Out of Tune

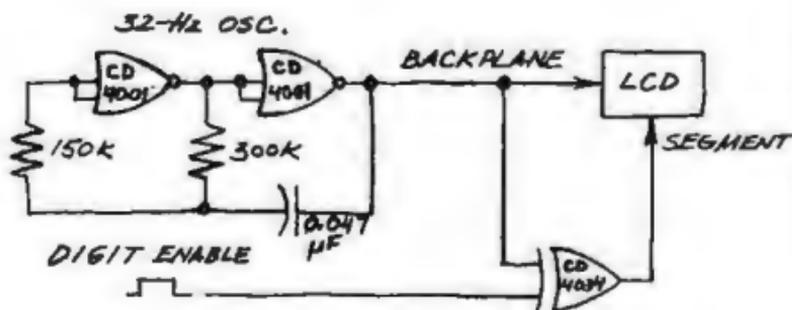
In "Getting to Know the Liquid Crystal Display" (April 1975), the schematic shown in Fig. 4 was incorrect. The corrected schematic is shown below. Also, to clarify understanding the theory behind LCD's, CMOS is preferred over TTL for driving the display because the output switches between the supply voltage and ground (instead of from about 4.7 volts and about 0.6 volt, as in TTL). This minimizes the undesirable effects of dc offset voltages.
